- 2. Seward Original Townsite Budd Replat; KPB File 2025-183**  
**Johnson Surveying / Budd, Spear-Budd**  
**Location: First Avenue**  
**City of Seward**

# Seward Original Townsite Budd Replat Preliminary Plat

**ITEM #2 - PRELIMINARY PLAT  
SEWARD ORIGINAL TOWNSITE BUDD REPLAT**

<b>KPB File No.</b>	2025-183
<b>Plat Committee Meeting:</b>	January 26, 2026
<b>Applicant / Owner:</b>	Eric Budd and Kay Spear-Budd of Anchorage, Alaska
<b>Surveyor:</b>	Jerry Johnson, Johnson Surveying
<b>General Location:</b>	First Avenue, City of Seward

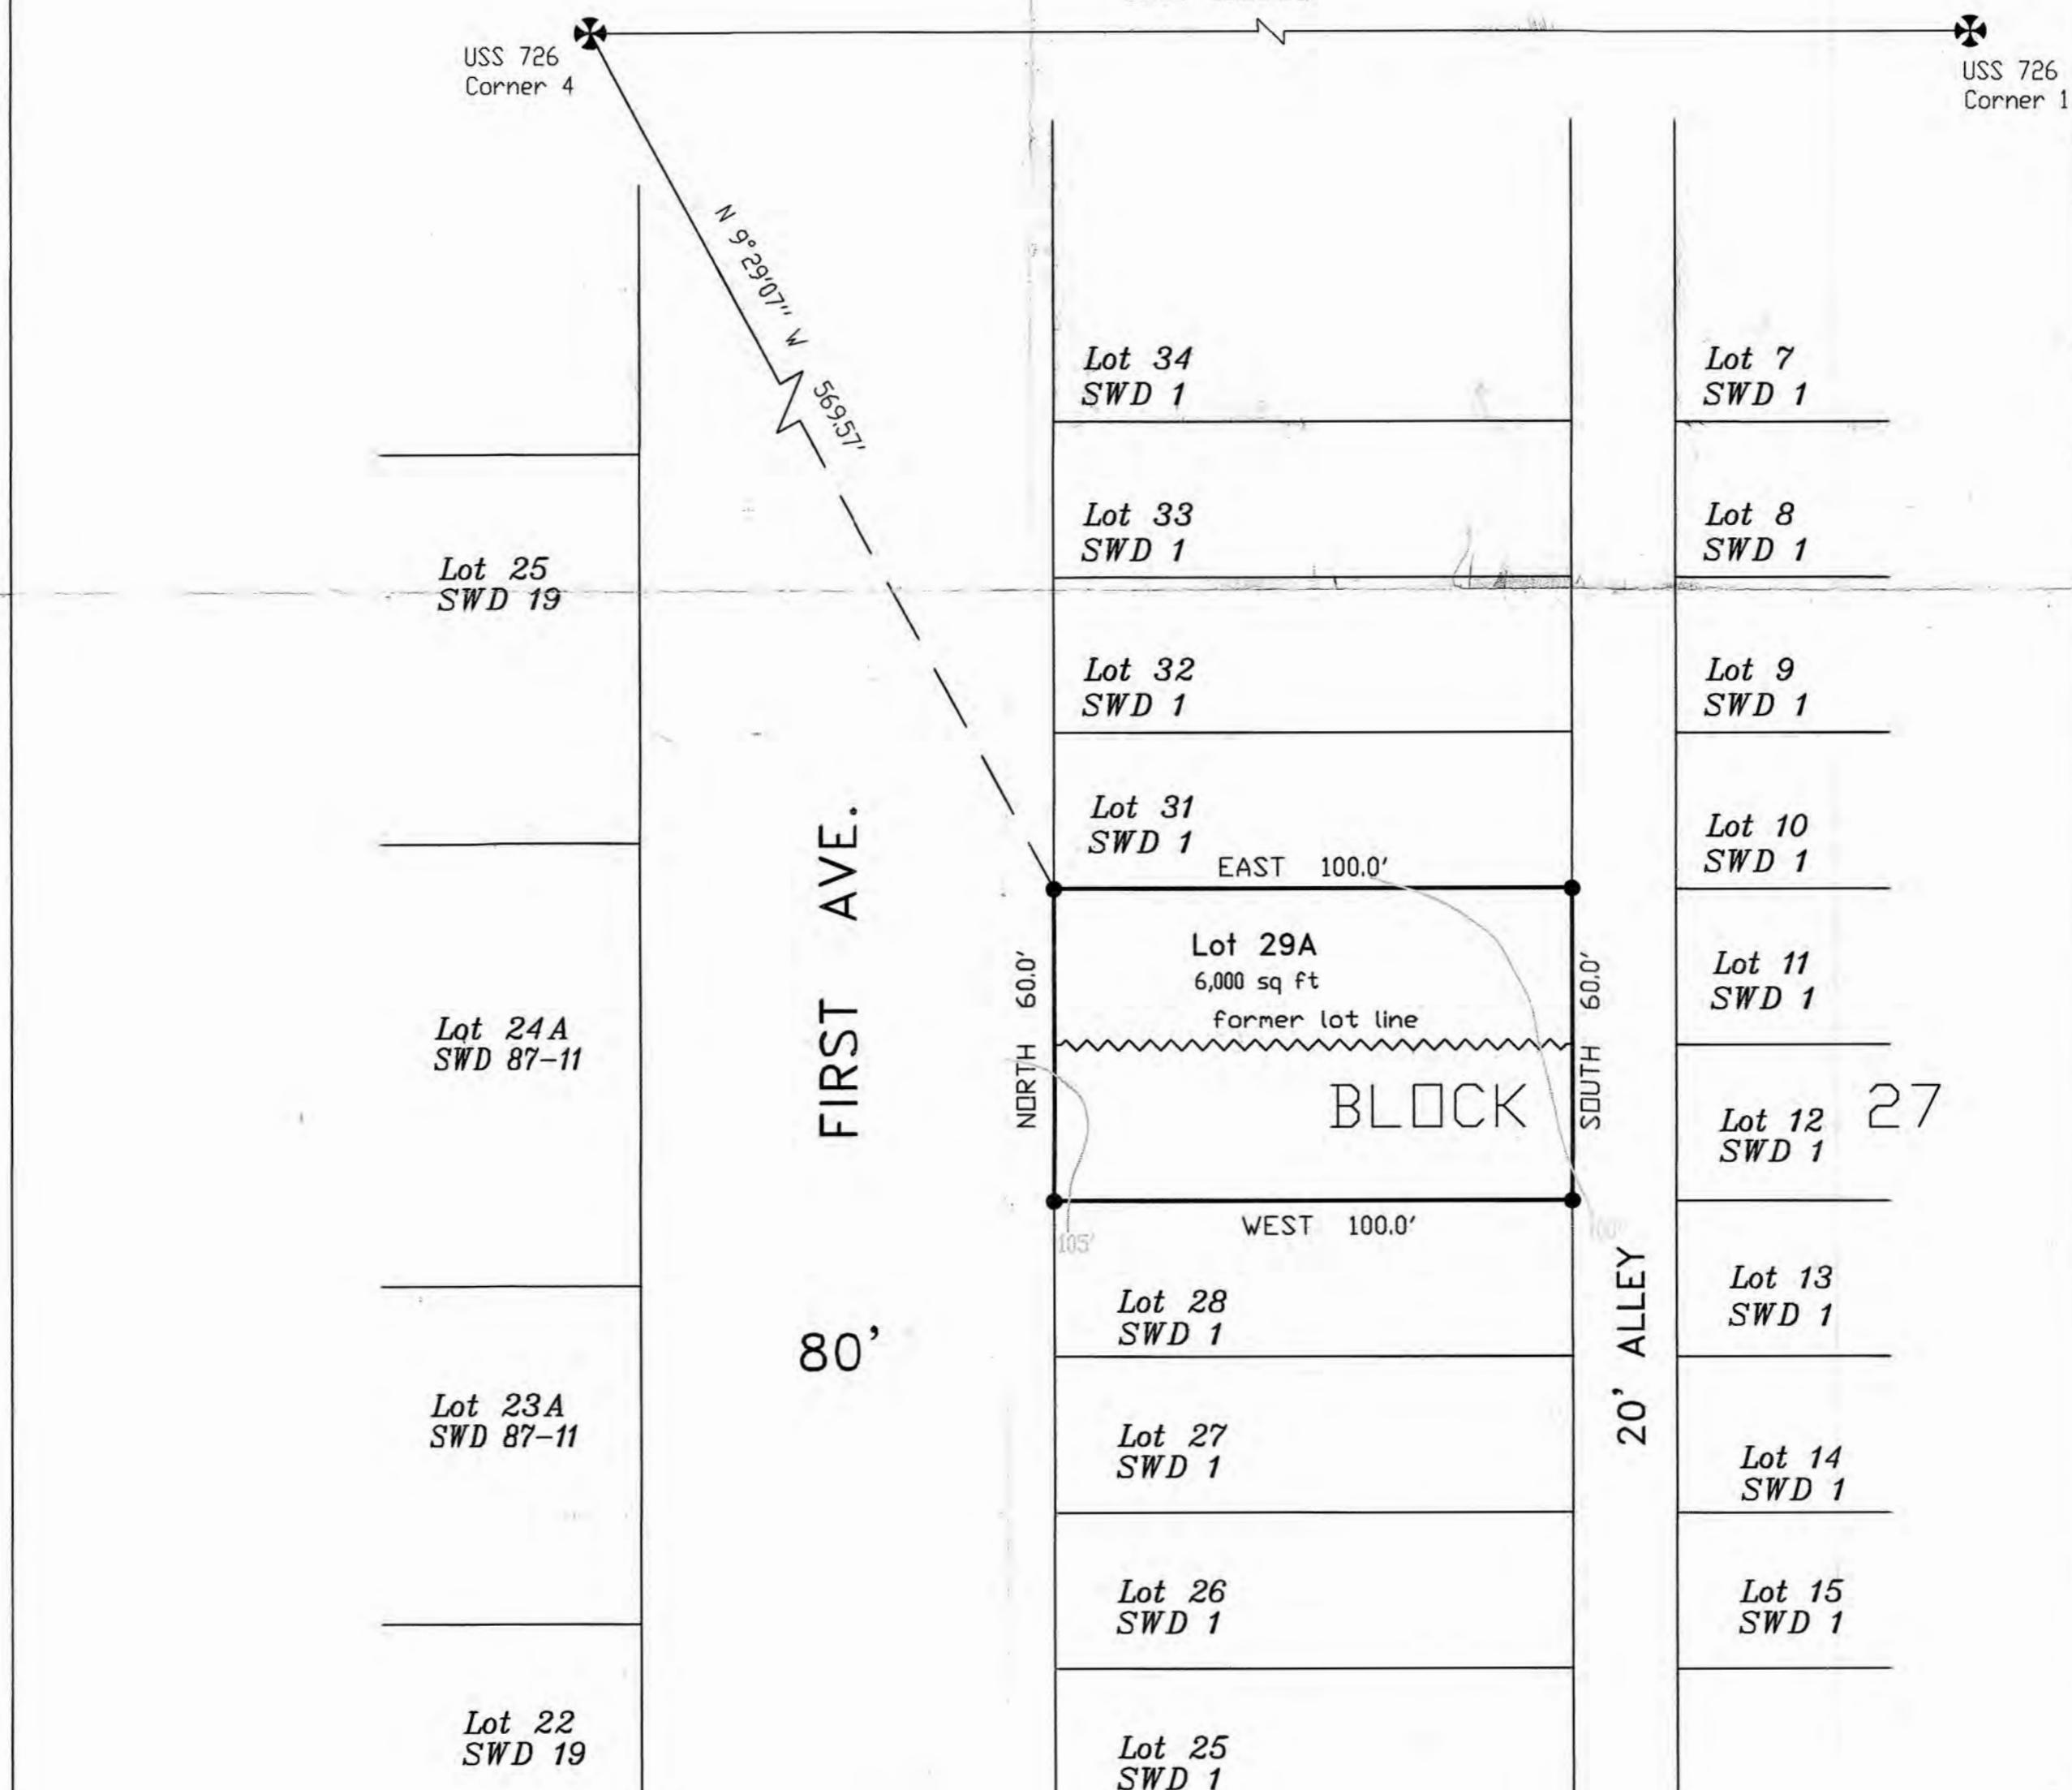
Contours are shown on the preliminary plat at 5-foot intervals, with no grades exceeding 20%. **Staff recommends** removing contours from the final plat pursuant to KPB 20.60.010, and modifying plat note #5 accordingly.

**Staff recommends** adding the following note to the plat referencing the Floodzone and map panel. No depiction is required:

Flood Hazard Notice: Some or all of the property shown on this plat has been designated by FEMA as a flood hazard area district as of the date this plat is recorded with the district recorder's office. The developer is responsible for contacting the city to determine any restrictions prior to any development for areas within a Floodzone and/or Floodway.

- Modify KPB File Number to 2025-183

- Convert total area to acreage
- Change prepared for to owners

- Depict section lines
- Modify street names: *First Avenue, Second Avenue, Third Avenue, Fourth Avenue, Fifth Avenue*
- Depict and label Lowell Creek
